Date 07.02.97	Ref. No. IP00297	Model CM-DX1000	TD
Subject Disassembly of Set			IRIS

Date 28.03.97	Ref. No. IP00397	Model CM-DX1000	TD
Subject Part number info: New Software			IRIS

Date 30.05.97	Ref. No. IP00997	Model CM-DX1000	TD
Subject Standby Time Abnormally Short			IRIS 1117

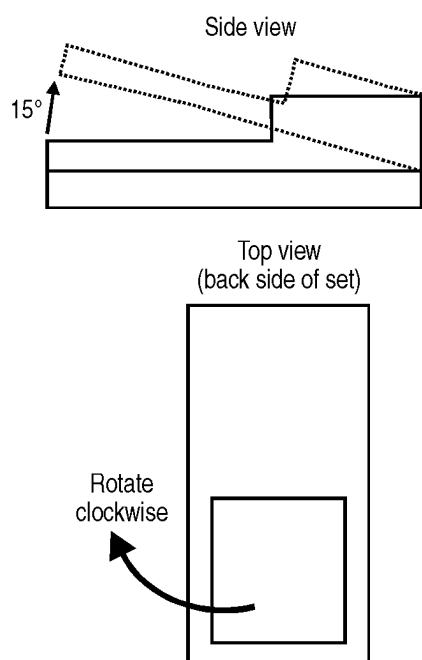
Disassembling the CM-DX1000 may lead to damage of the Upper or Lower Case Shell due to incorrect handling.

The factory assembly of the CM-DX1000 cosmetics is rather tight, and on the upper side, both major parts are held together by claws.

- Remove the Antenna.
- Remove the Battery Cover and the Battery.
- Remove the SIM Card Holder.
- Remove four screws in the Battery Compartment.
- Hold the set in your hand with the display side in the palm of your hand.
- Take the Lower Case Shell at its bottom part (i.e. bottom of the Battery Compartment) and lift this part to an angle of approximately 15°.
- Now rotate the Lower Case Shell clockwise. You will meet some resistance. A loud click will be audible (releasing of the claws) and the Lower Case Shell will be correctly loosened.

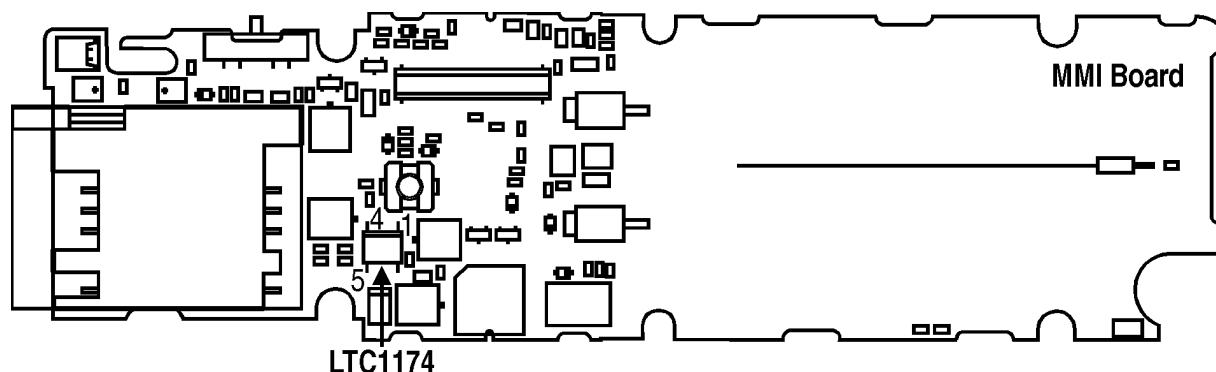
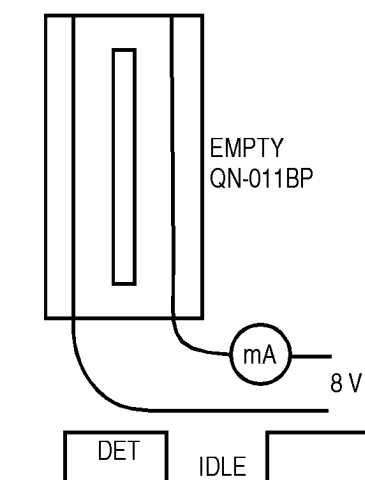
The standby time is abnormally short so that the impression may arise that the battery is defective, or the battery is never totally charged.

Defective IC LTC1147 on the MMI Board.

Using a voltmeter, measure the voltage between GND and pin 4 or 5 of IC LTC1174 while the unit is powered on. The voltage should range between 1.24 ~ 1.28V. **A voltage of >1.3V indicates that the LTC1147 IC is defective.**

Replace IC **LTC1147** (8-759-336-22). The part is accessible on the MMI Board after removing the Lower Case Shell and the RF Unit.

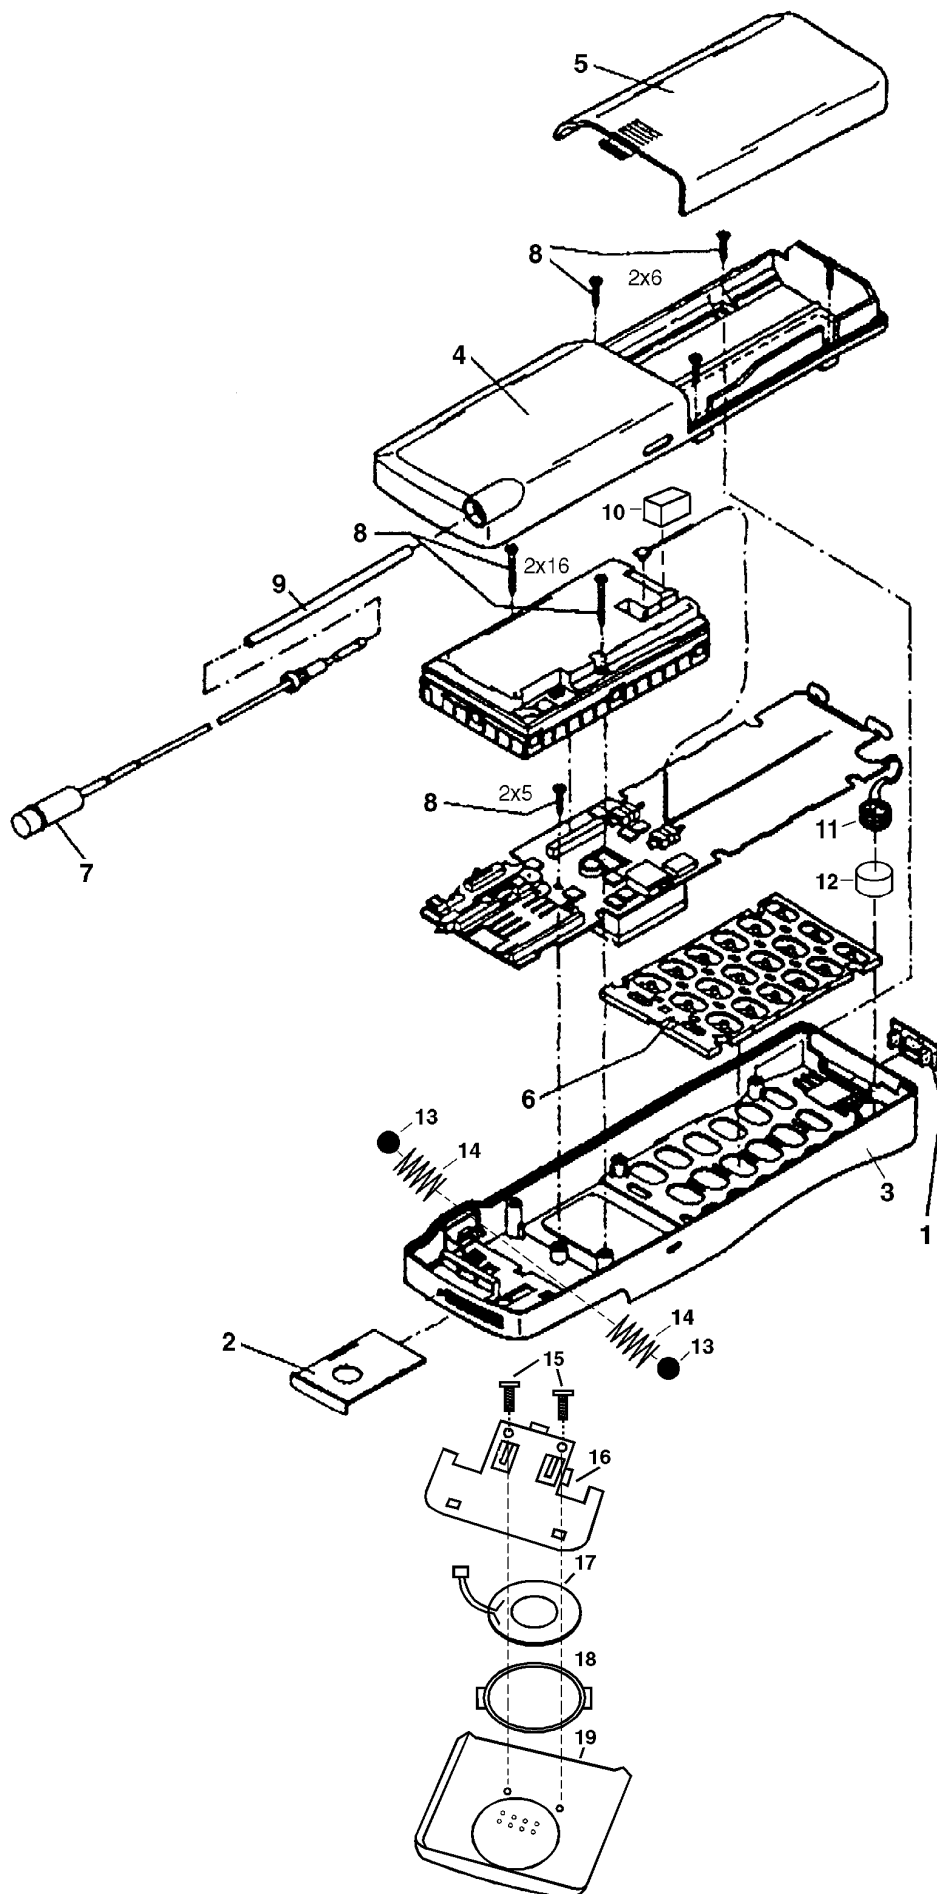
Add the following parts to the exploded view and the parts list.

<i>Ref. No.</i>	<i>Part number</i>	<i>Description</i>
3	X-3369-697-1	Upper Case Shell without Earphone
10	3-923-081-01	Spacer (B)
11	1-542-256-11	Microphone
12	3-920-741-01	Microphone Holder
13	7-671-155-01	Steel Ball (3.0)
14	3-920-743-01	Coil Spring
15	3-920-748-01	Torx Screw (1.7x6)
16	3-920-737-01	Receiver Case (Lower)
17	1-504-764-11	Speaker
18	3-920-740-01	Receiver Holder
19	X-3369-699-1	Receiver Case Subassy
Accessories		
	S-2000-001-0	Instruction Manual (English)
	S-2000-002-0	Instruction Manual (French, Dutch)
	S-2000-003-0	Instruction Manual (German, Italian)
	S-2000-004-0	Instruction Manual (Norwegian, Swedish)
	S-2000-005-0	Instruction Manual (Spanish, Portuguese)
	S-2000-006-0	Instruction Manual (Danish, Finnish)
	S-2000-007-0	Instruction Manual (Greek, Hungarian)
	S-2000-008-0	Instruction Manual (English, Turkish)
Jigs & Tools		
	S-1974-001-0	Antenna Removal Tool

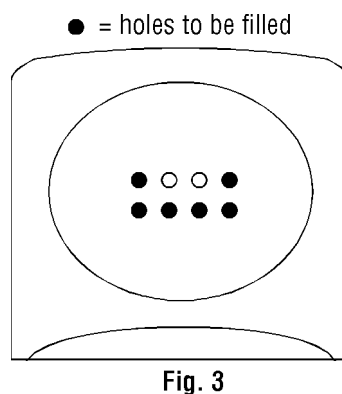
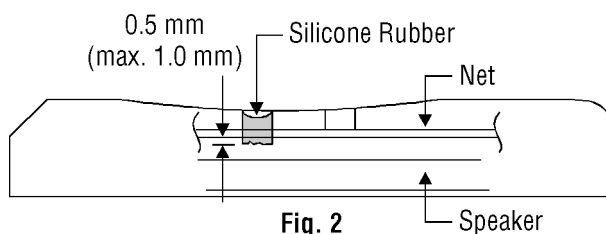
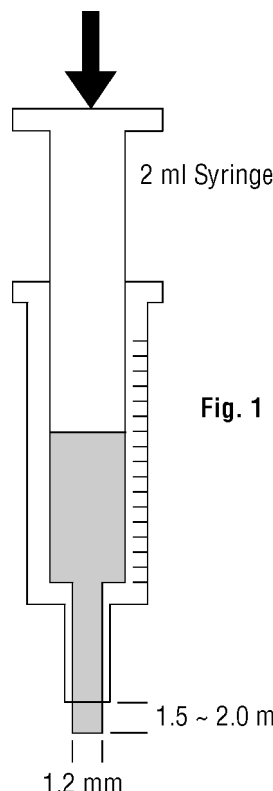
Resonance between the Speaker and the Receiver Case.

Modify the Receiver Case (Earpiece Pop-up) by filling six of the eight holes with silicone rubber.

- Apply pressure to the syringe until a small amount of silicone comes out, approx. 1.5 to 2 mm of silicone as shown in Figure 1. This amount is sufficient to fill one hole. Hold the syringe vertical to the hole to be filled and make certain that all of the silicone is pushed inside the hole. The amount of silicone used to fill the hole is critical: if too much is used, the silicone will penetrate the speaker net and might touch the speaker (Figure 2). Repeat the process for all of the six holes indicated in Figure 3.

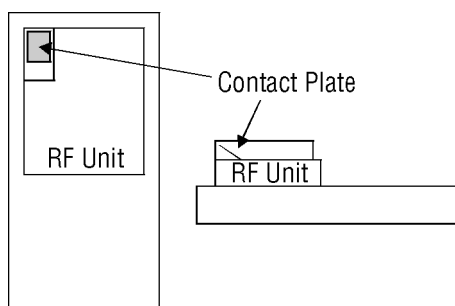
- Loss of network connection.
- No initial connection to network.
- Dropouts during connection.
- Short battery lifetime (due to constant network search).
- Low RF readout in monitor mode.

Poor or no connection between antenna and RF unit.

Check the position of the contact plate on the RF unit. The plate should be correctly soldered and should be pointing upwards.
